1242, 1250, 1260, 1270 Gordon Street and 9 Valley Road, Guelph, ON – Environmental Impact Study Addendum

Report

August 30, 2021 File: 161413684

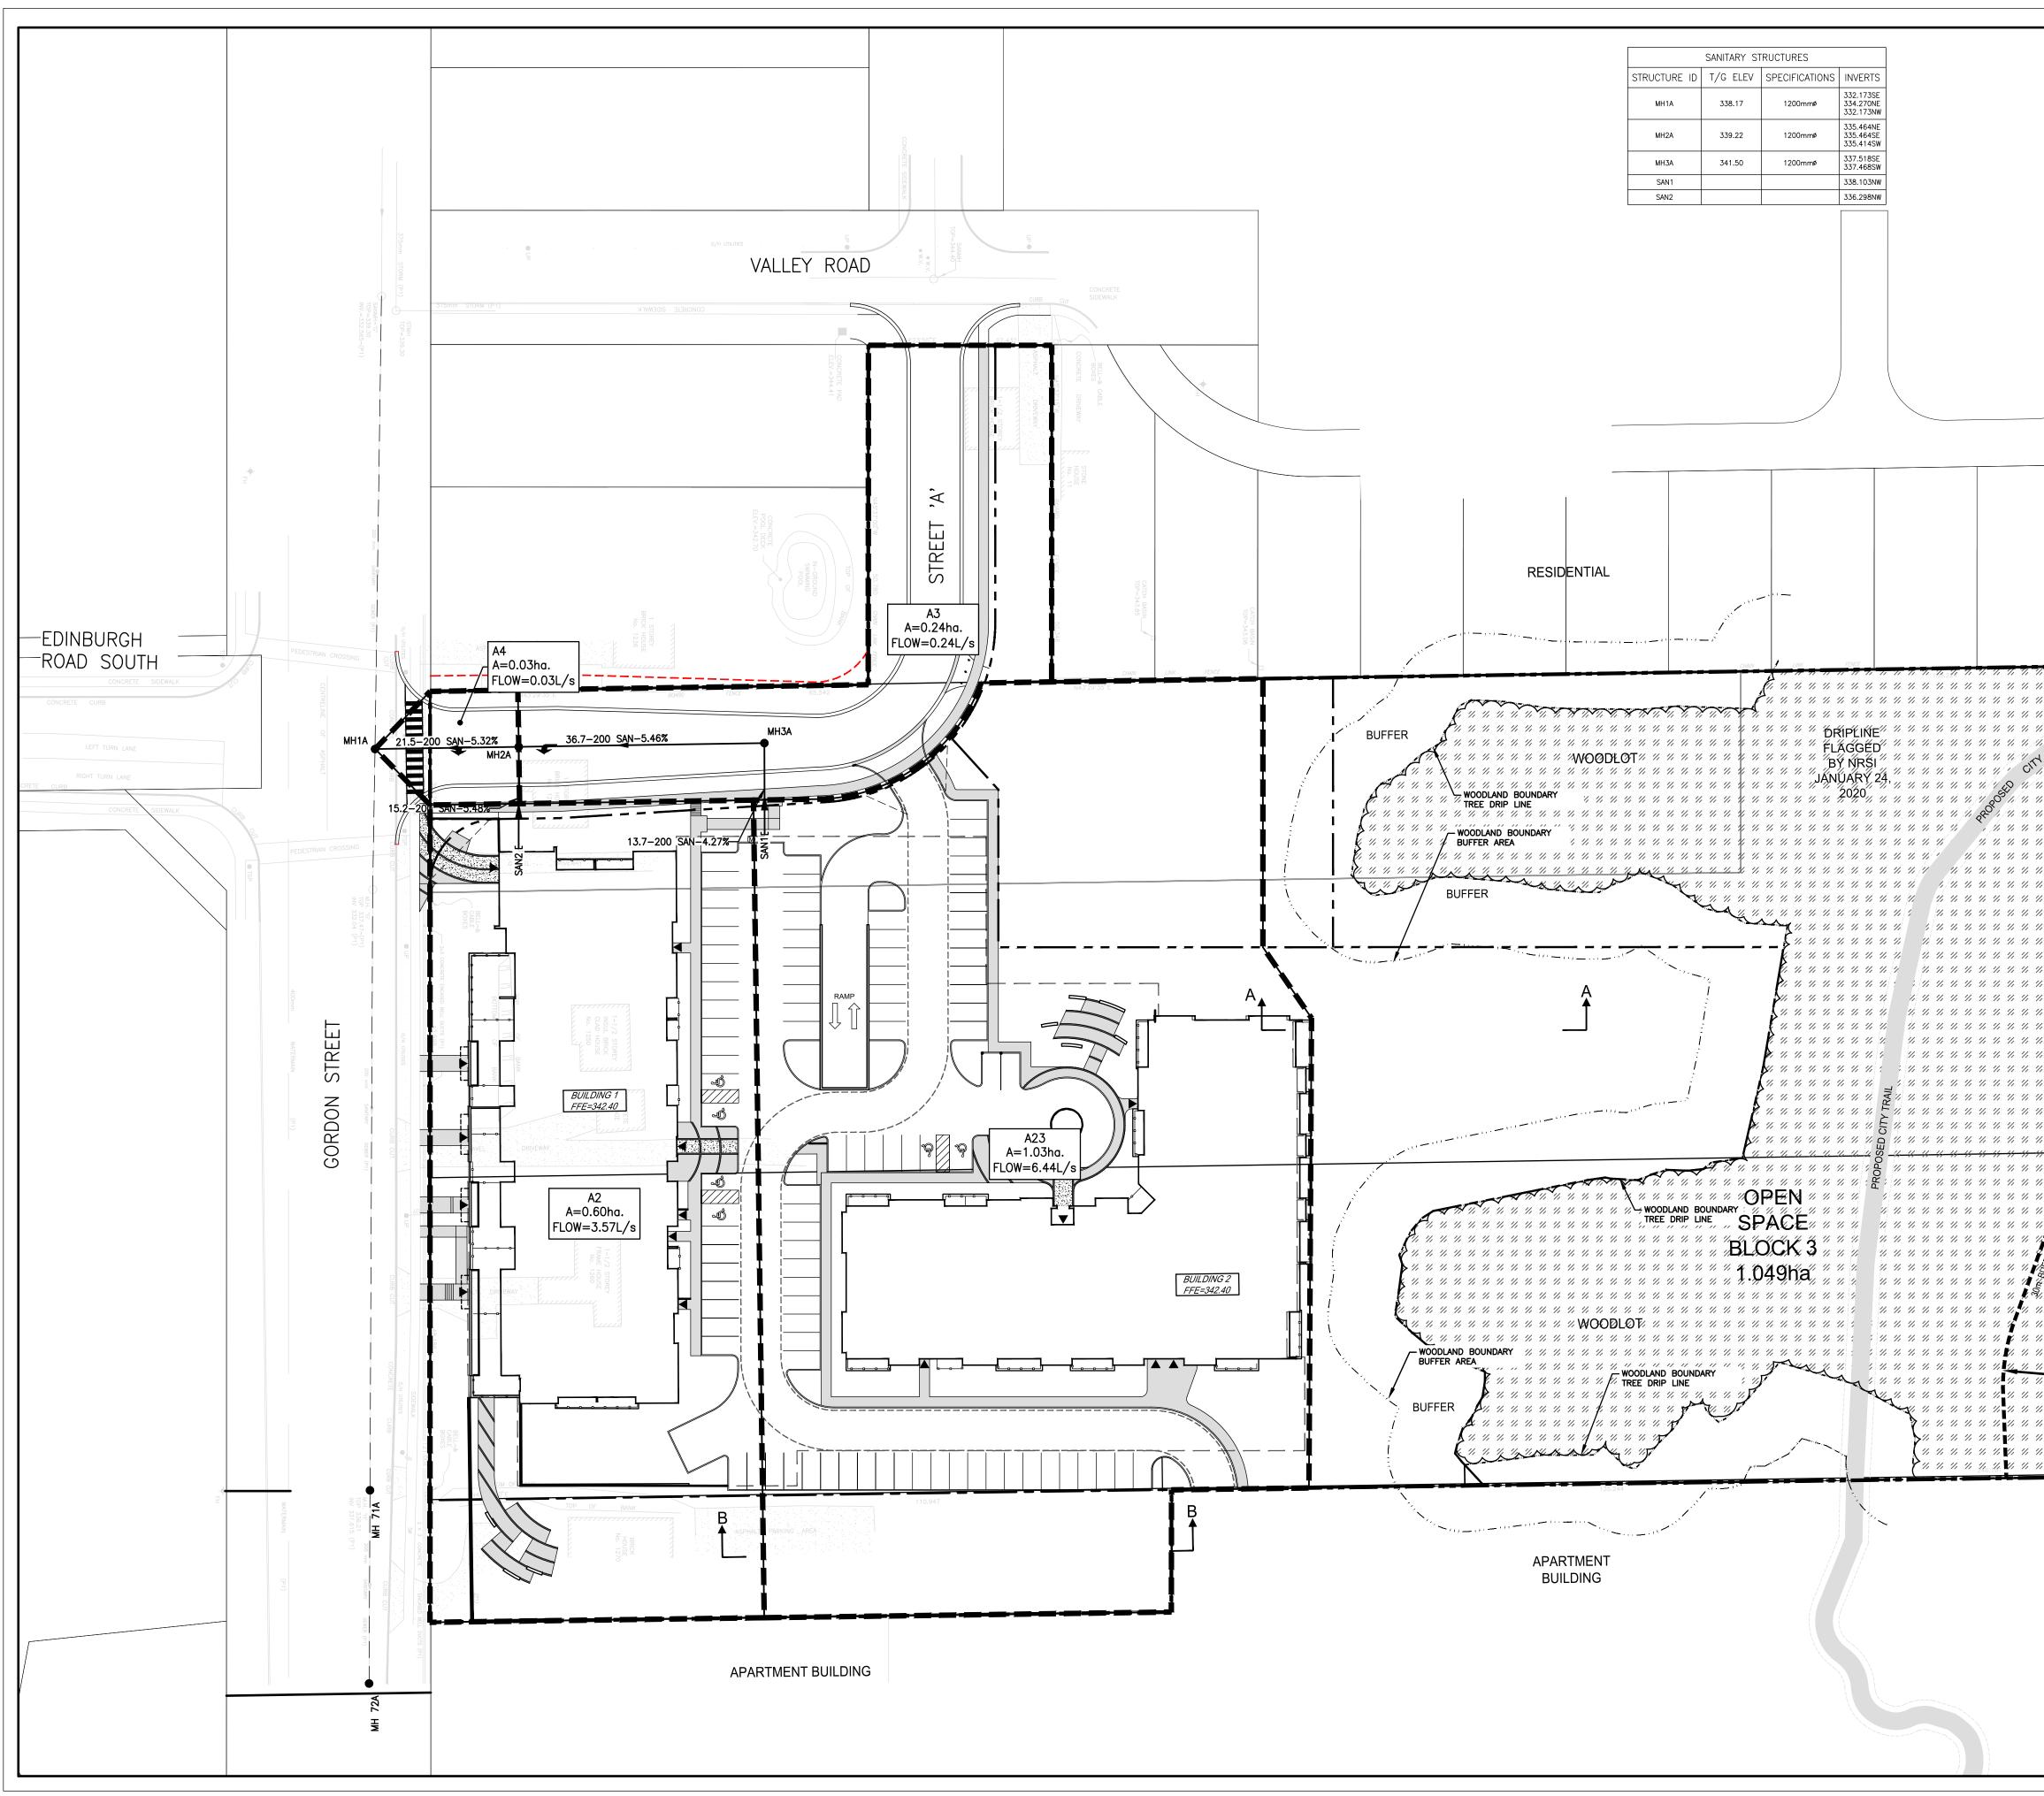
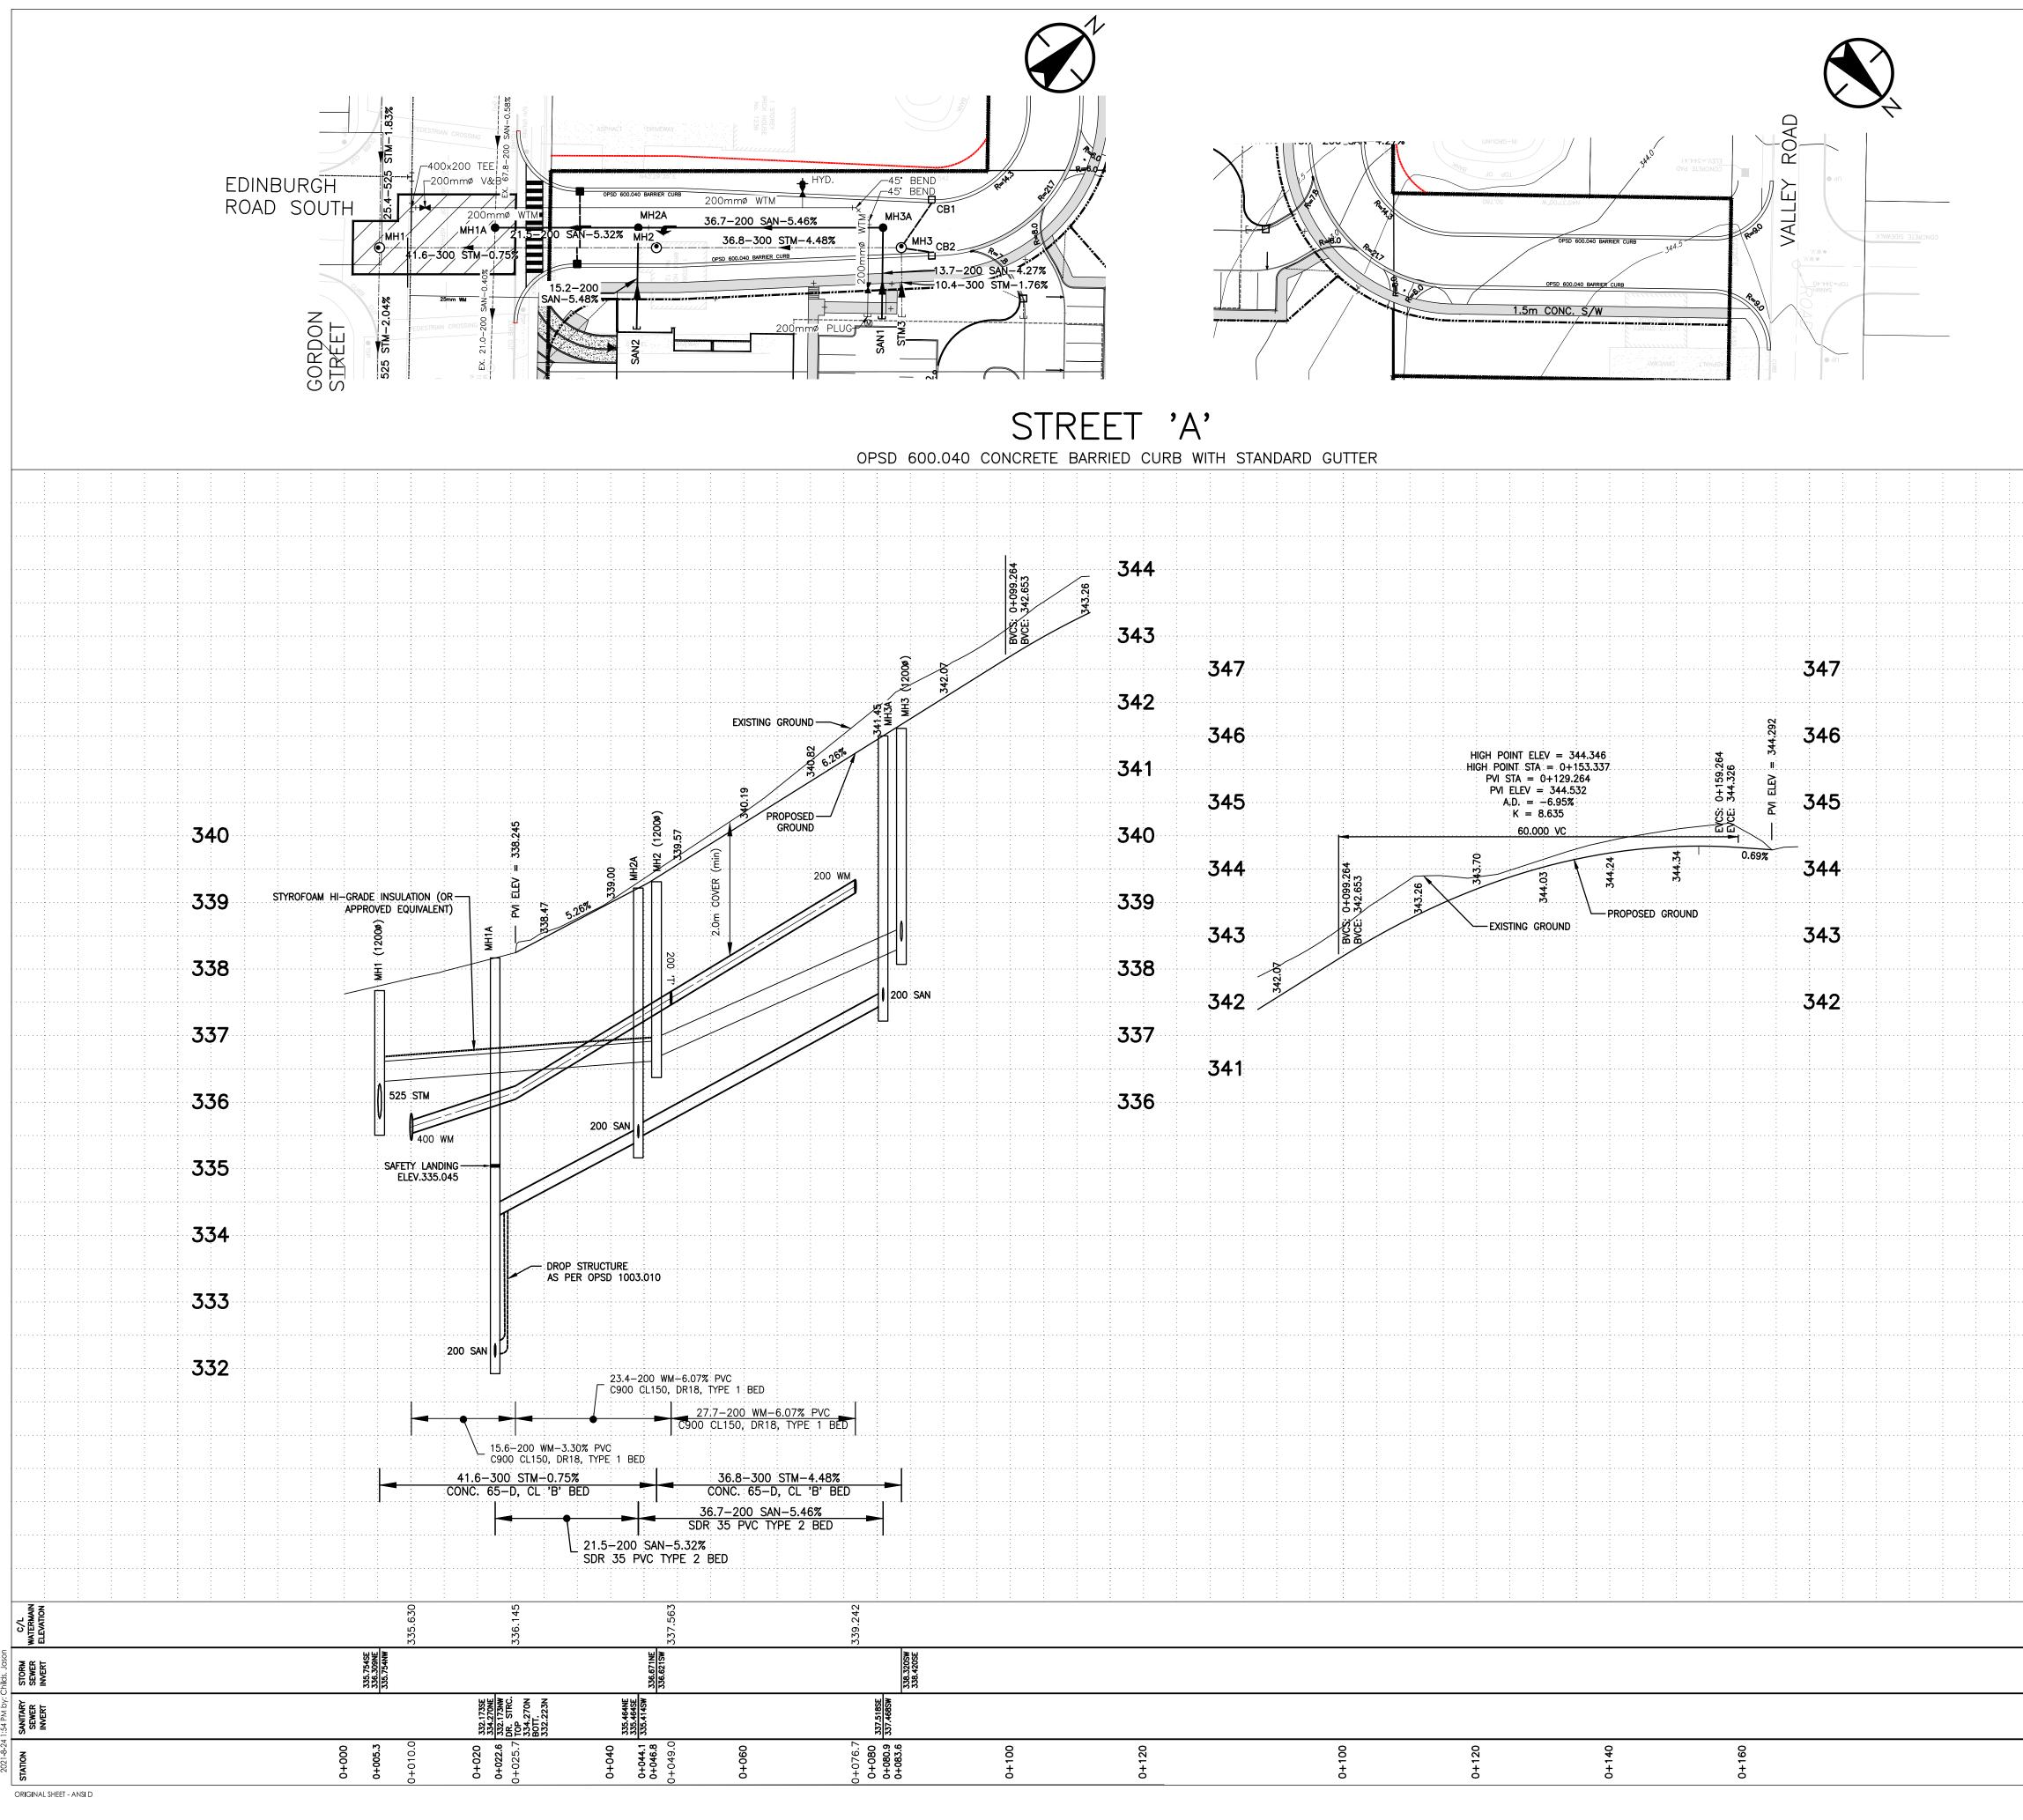
- 60.Drawing SSP-2 Storm Drainage Area Plan It is unclear how the Area IDs relate to the Catchments described in the FSR and Hydrological Investigation report's water balance calculations. Please ensure that this is clarified and coordinated among studies and drawings in the next submission.
